# WaterFix Sea Level Rise Assumptions

### **Delta Stewardship Council Draft Staff Determination on WaterFix Consistency Appeal, 2018**

### **Delta Independent Science Board, 2013**

#### 140 cm Sea Level Rise

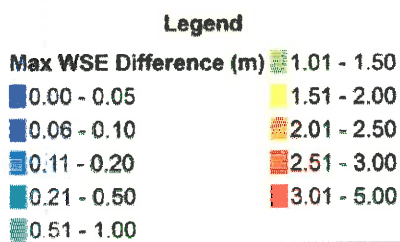
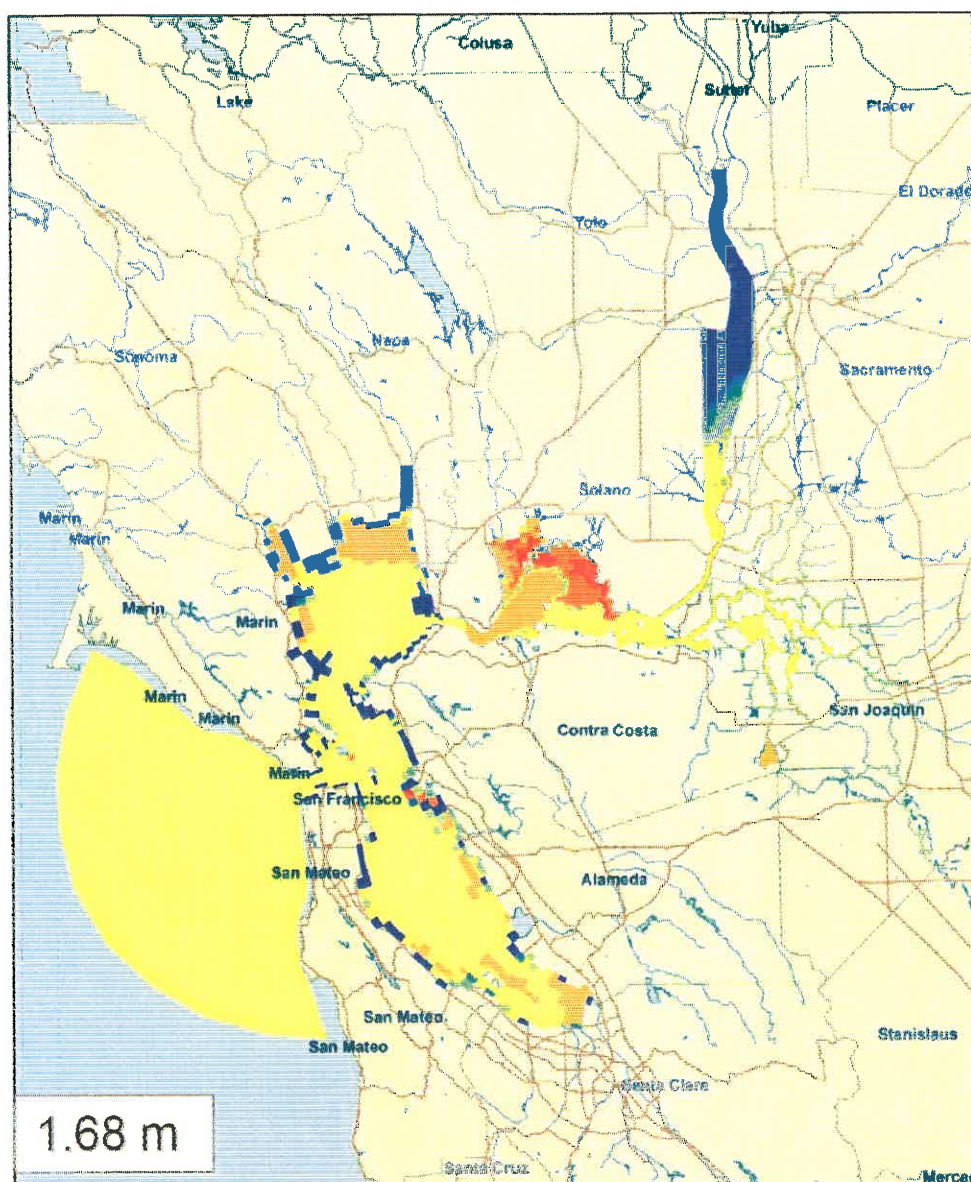
The simulation was just a variation of RMA's study of the Hayward earthquake scenario for the Delta Risk management strategy. The breaches of levees mostly in the southeast and southwest Delta was based on assumed impacts from a large earthquake on the Hayward fault.

There was no consideration that sea level rise and levee failures in the Central and Western Delta would cause levee failures in the Northern Delta. There is NO OTHER modeling showing that the water at the intakes at Hood will stay fresh with high sea level rise.
